COUNTY OF HENRICO
VIRGINIA

TO:	Planning Office	SUBJECT:	POD2016-00034: O'Reilly Auto Parts
FROM:	Henrico County Police Division, Community Services Unit	DATE:	February 10, 2016

POD2016-00034

<5915 West Broad St – prel plan - retail store>

Photo A. Shielded wall pack.

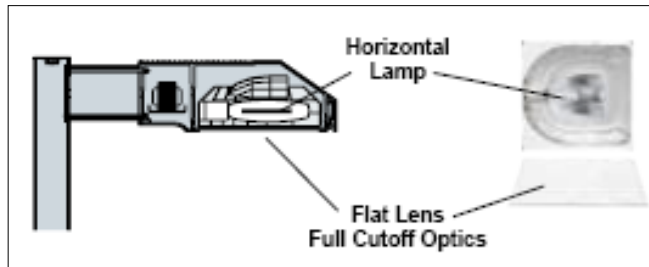
9. All light fixtures need to be full cut-off. See Photo's A and B for examples of full cut-off wall packs and pole lights.
10. Should post top fixtures be used, these fixtures also need to be full cut-off so that the light will be directed down to the ground, versus horizontally and up in the air. If decorative fixtures are installed,

they should have the lamp in the top casing of the fixture so that the light will be directed towards the ground (See Photo C). This will also avoid glare because you don't actually see the lamp. Glare is defined as horizontal light that hinders vision.
